WEST END REGIONAL NAVIGATION CENTER PROJECT
BID NO.: DE-26-222-SB

Addendum No. 2 Information
June 16, 2026

4.1 **Revised** "WEST END REGIONAL NAVIGATION CENTER" Plan Sheets are hereby included and shall replace the previously released "WEST END REGIONAL NAVIGATION CENTER" Plan Sheets. Changes to Plans include:

A-5

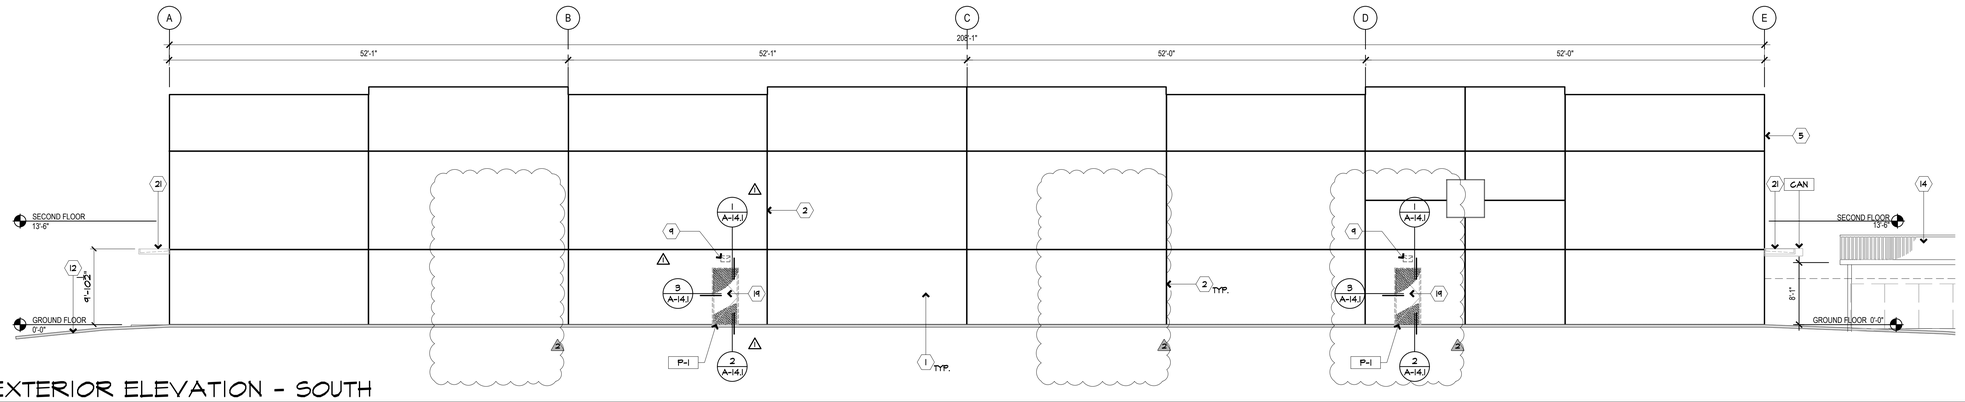
ee. **Sheet A-5:** Omit roof screen Detail 23. Omit exterior canopies at reconfigured south dorm room area egress doors. Clarify Plan Keynote No. 13 to include roof “to match existing” roof specification.

A-6.3

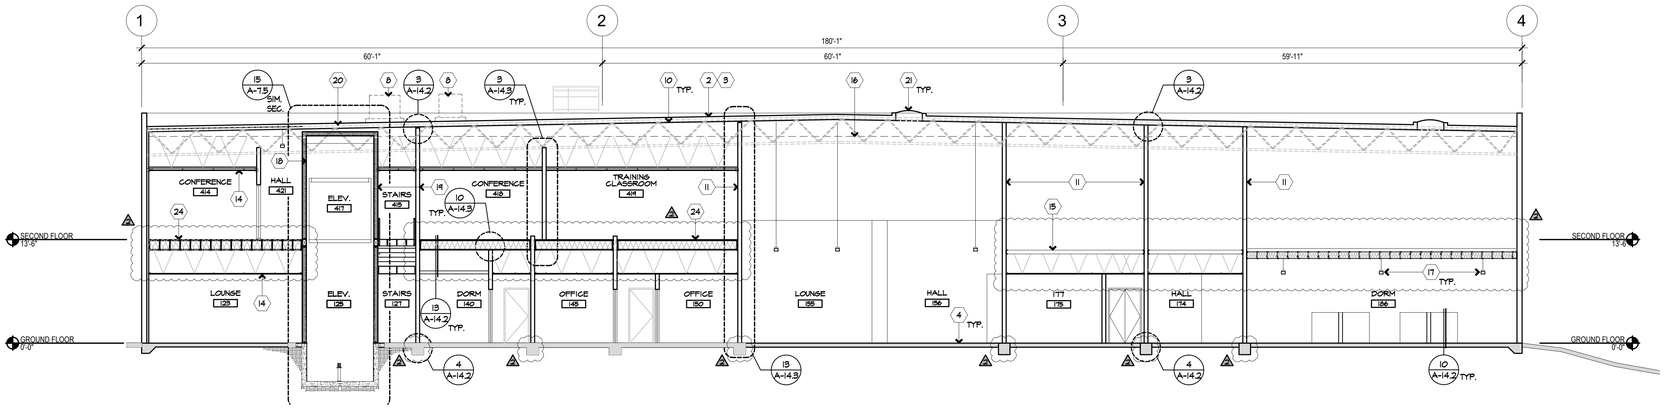
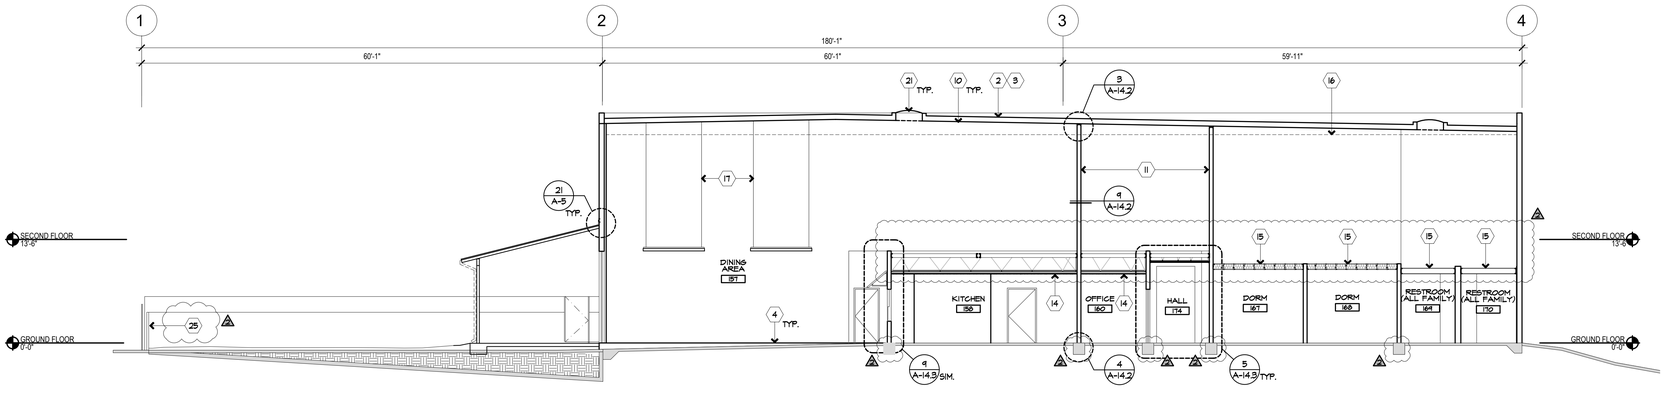
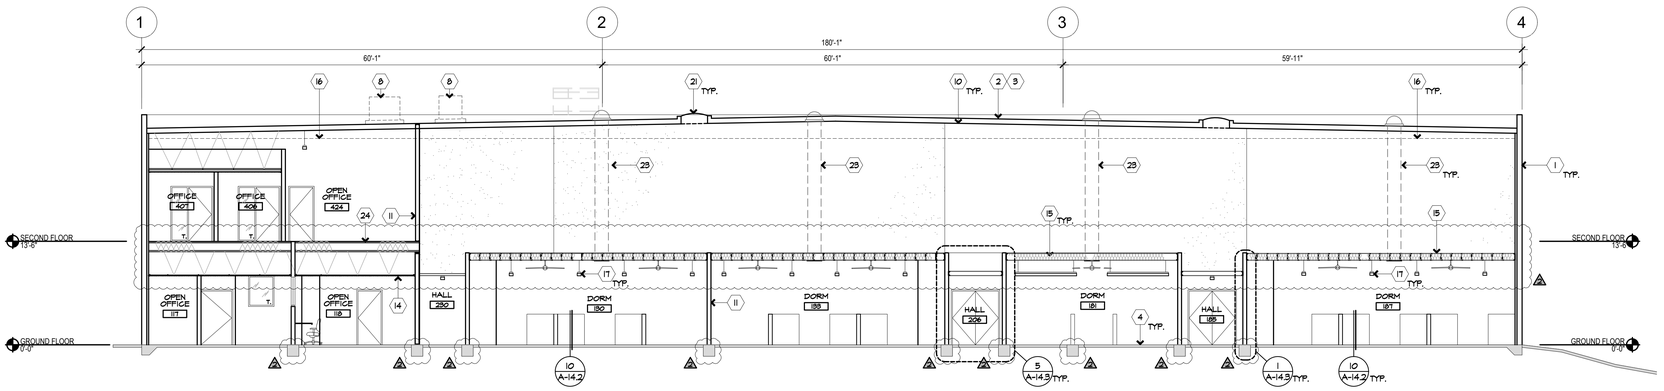
gg. **Sheet A-6.3:** Add new west stair sections. Clarify gyp-board requirements at east stair/elevator sections. Clarify Sections 9 and 10 for structural elements and insulation locations.

A-8.1

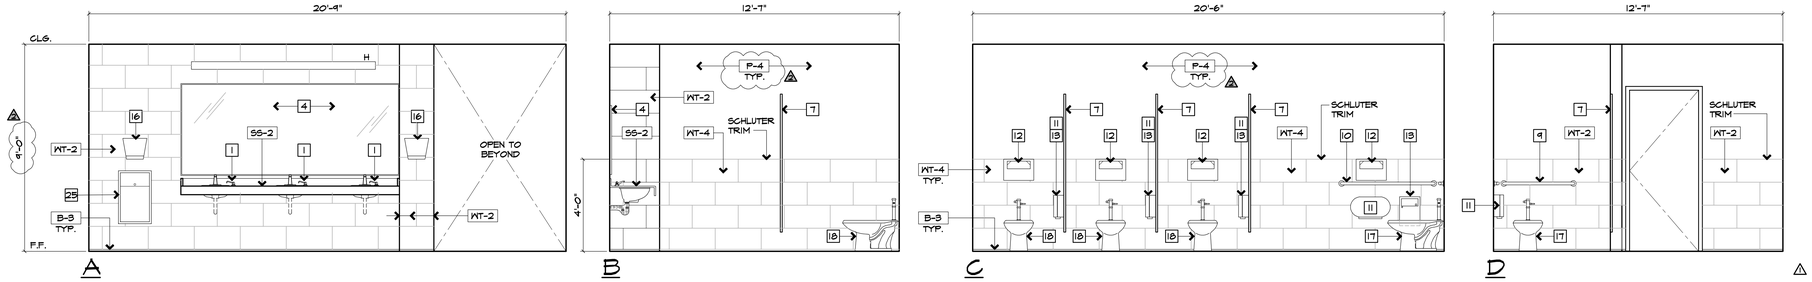
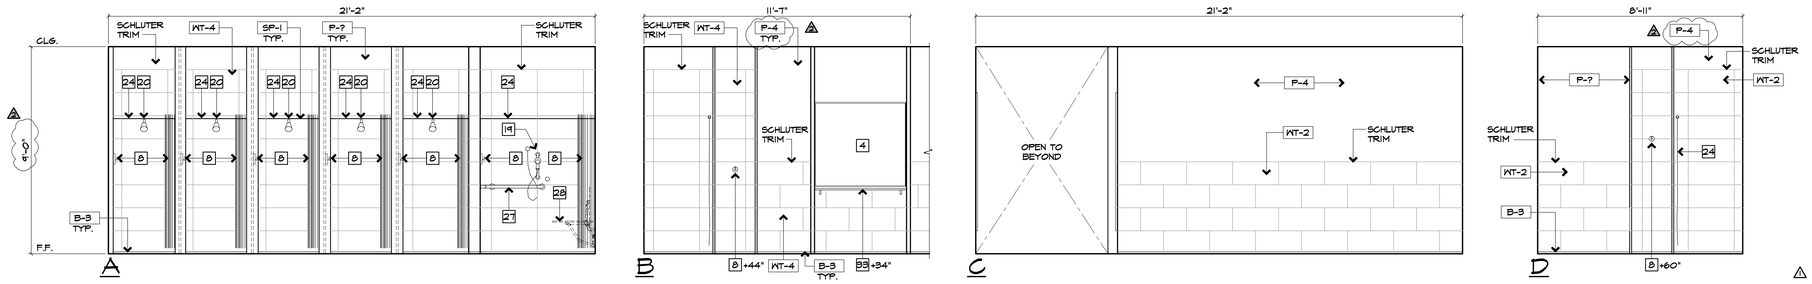
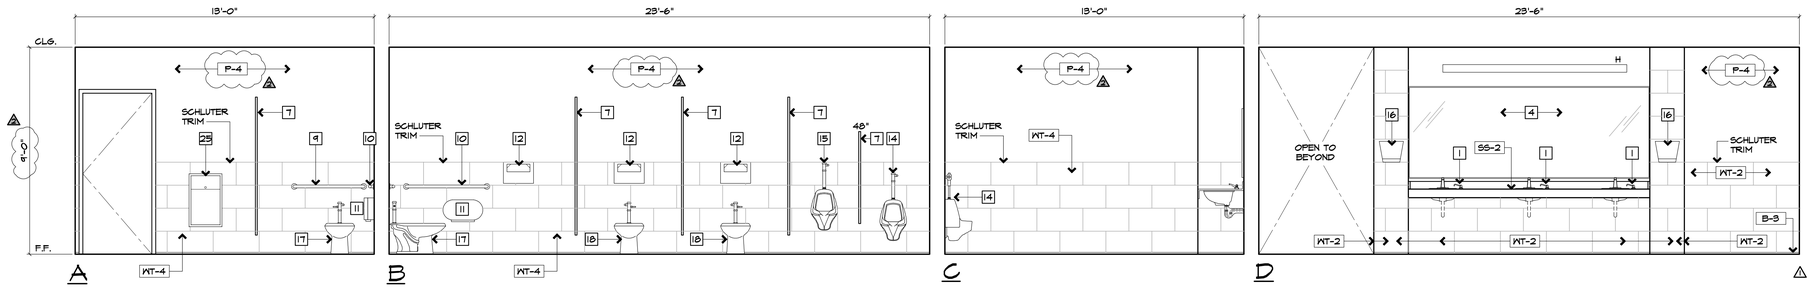
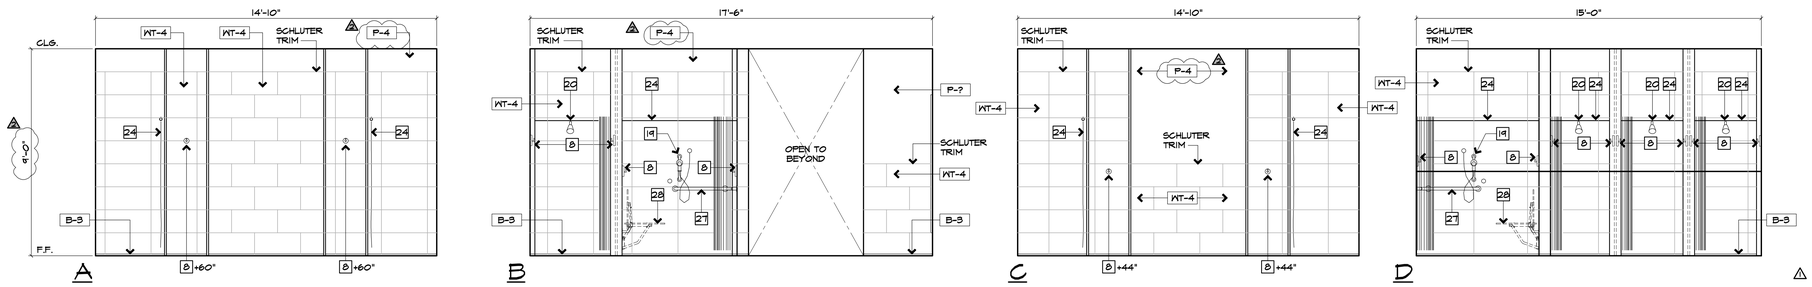
nn. **Sheet A-8.1:** General: All Paint colors have been identified on the Finish Floor Plan. All Finish General Notes, Finish Plan Key Notes and Finish Legend have been updated.

A-8.2

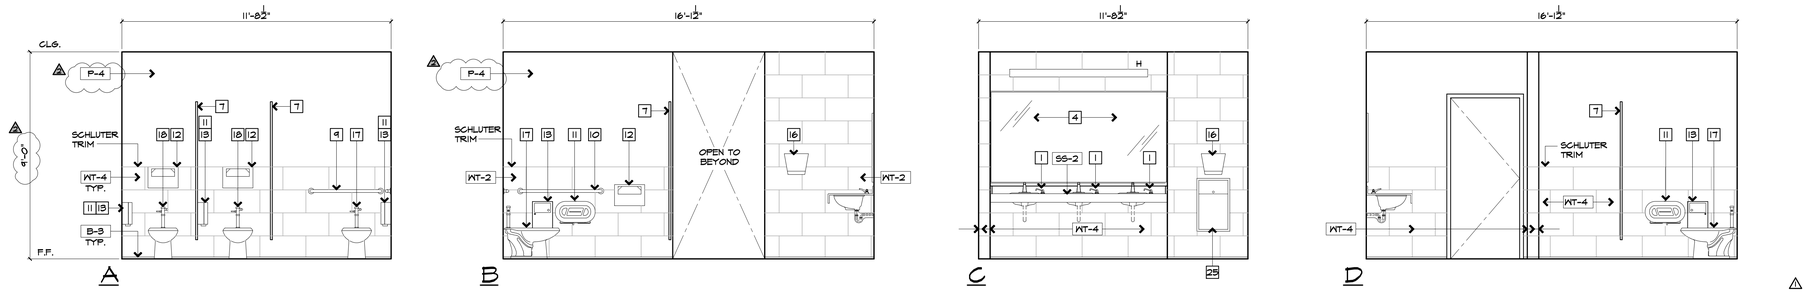
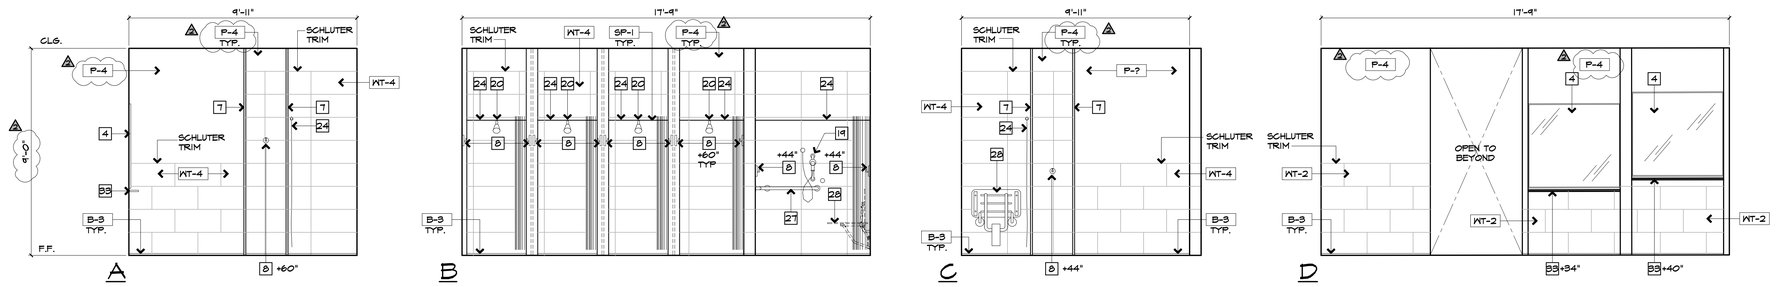
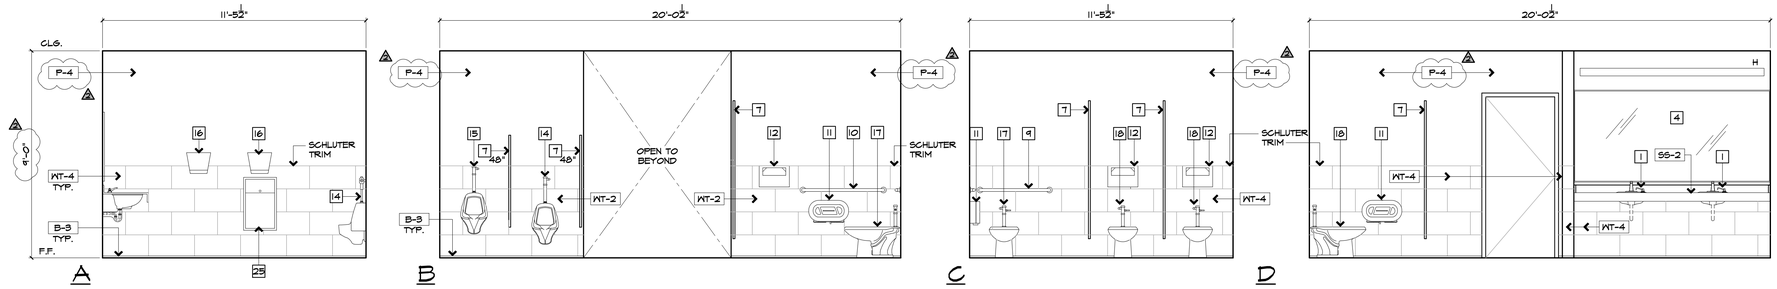
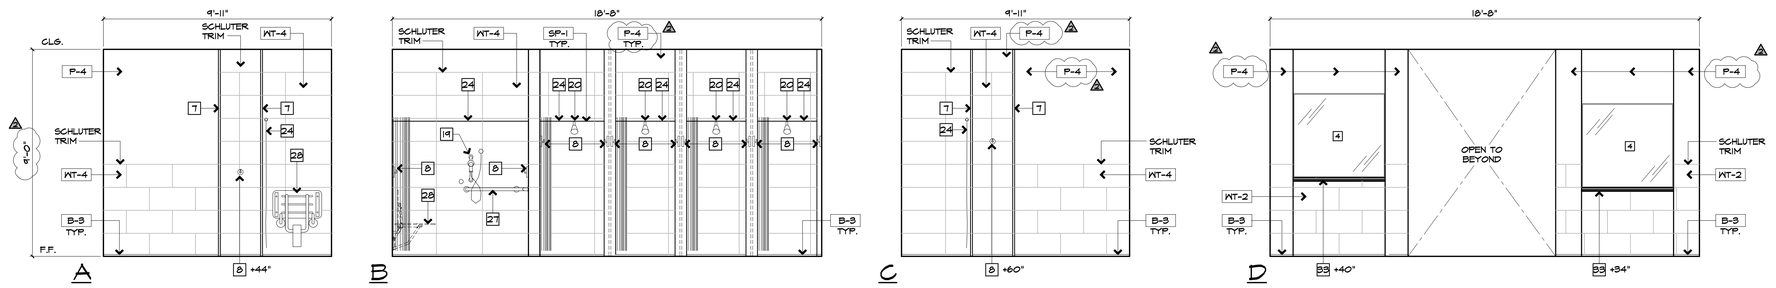
oo. **Sheet A-8.2:** General: Paint colors have been identified on all elevations.

P011

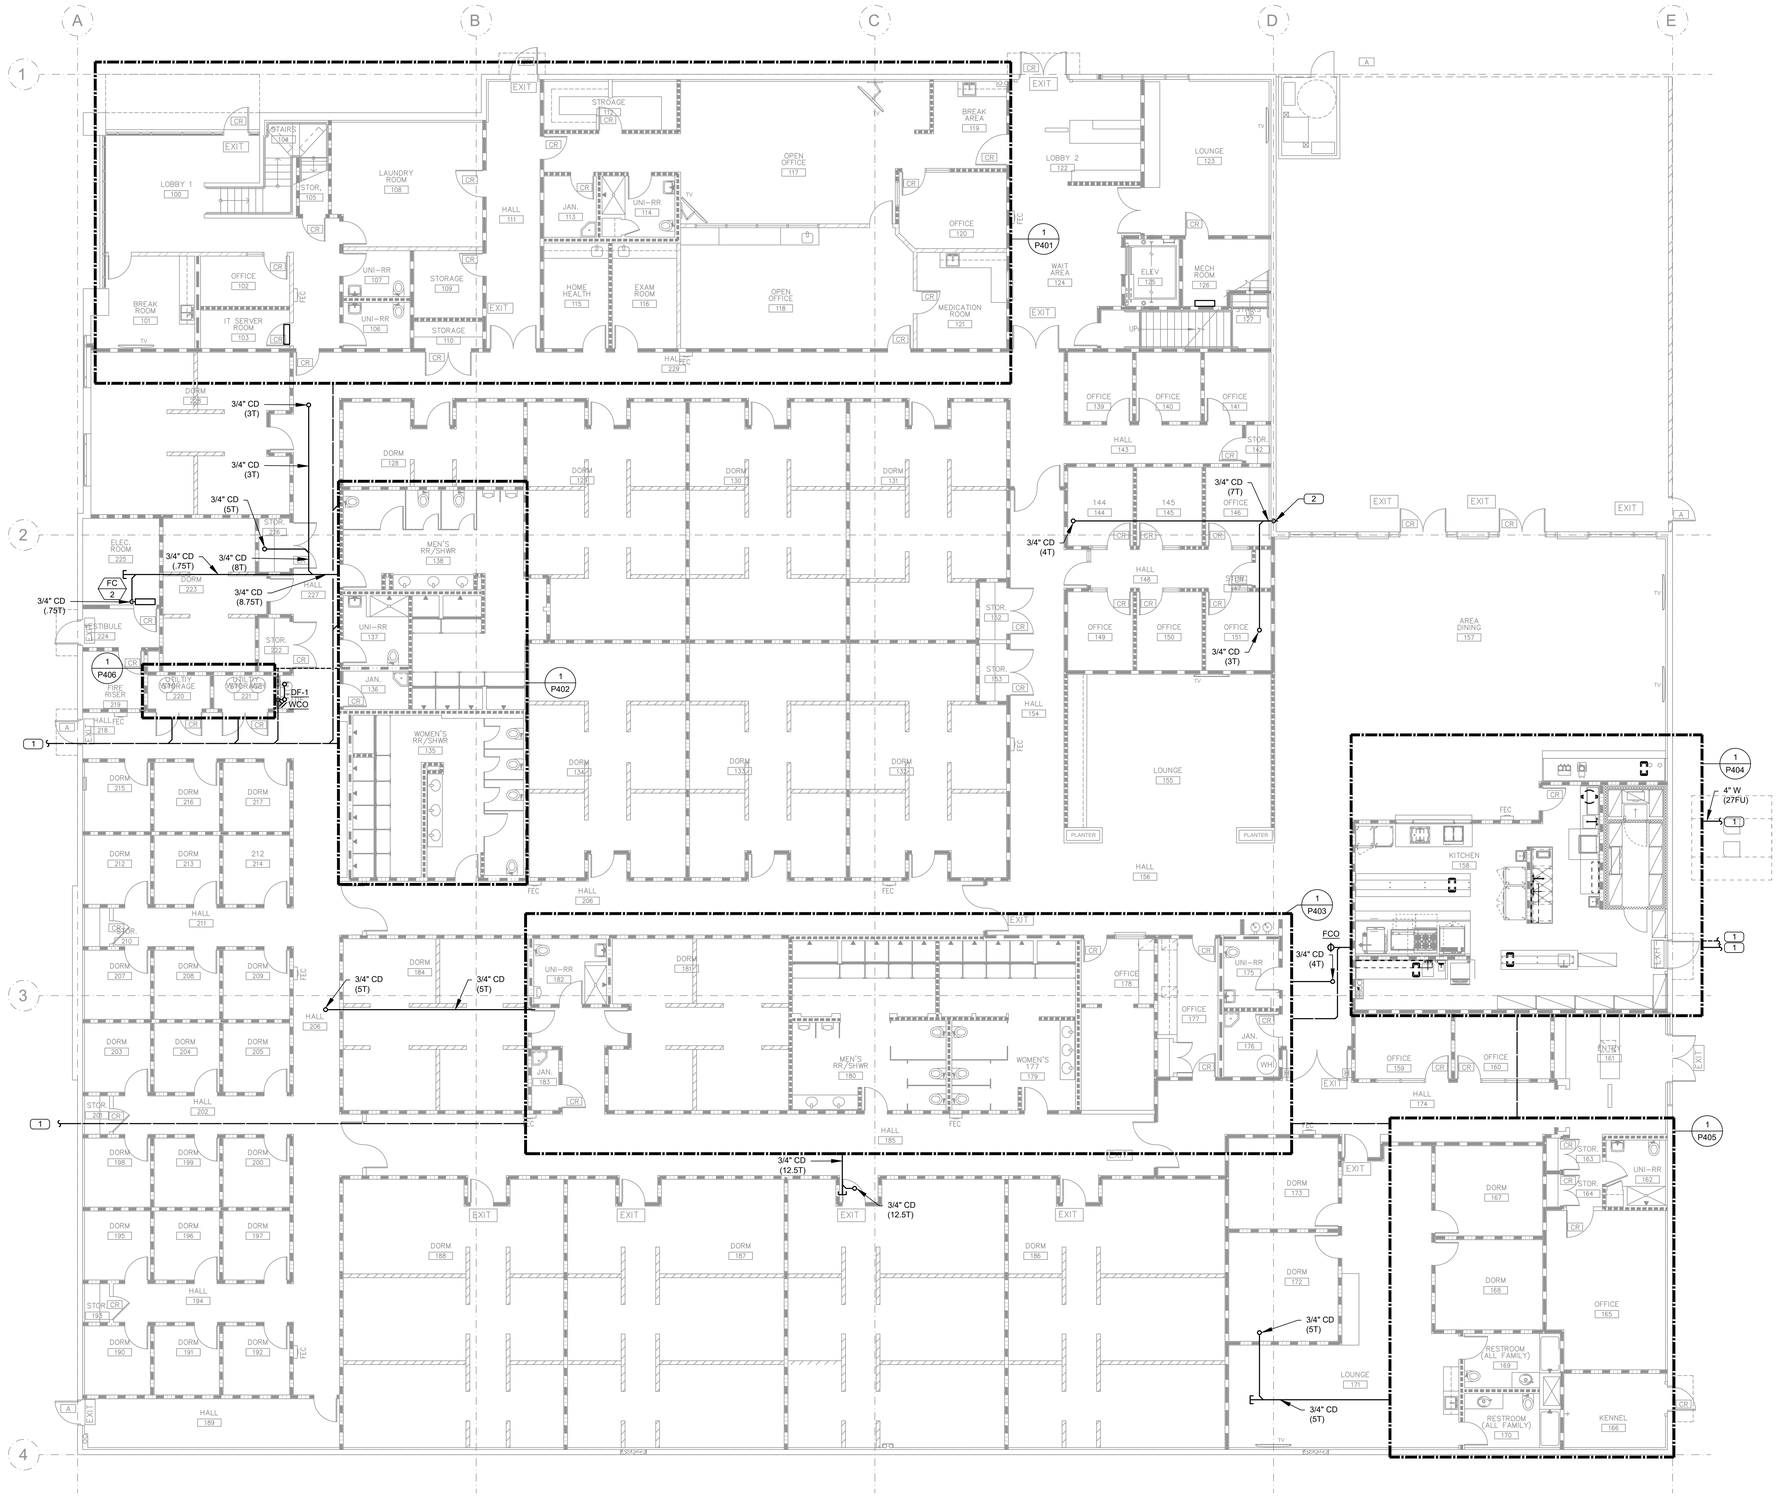
ggg. **Sheet P011:** Updated Condensate Drain Sizing Table and Low-Pressure Gas Pipe Schedule to be 2025 code cycle.
hhh. **Sheet P201:** Revised General Note #20 to be 2025 code cycle.
iii. **Sheet P202:** Revised General Note #20 to be 2025 code cycle.
jjj. **Sheet P211:** Revised General Note #20 to be 2025 code cycle.
kkk. **Sheet P301:** Revised General Note #20 to be 2025 code cycle.
lll. **Sheet P302:** Revised General Note #20 to be 2025 code cycle.
mmm. **Sheet P401:** Revised General Note #20 to be 2025 code cycle.
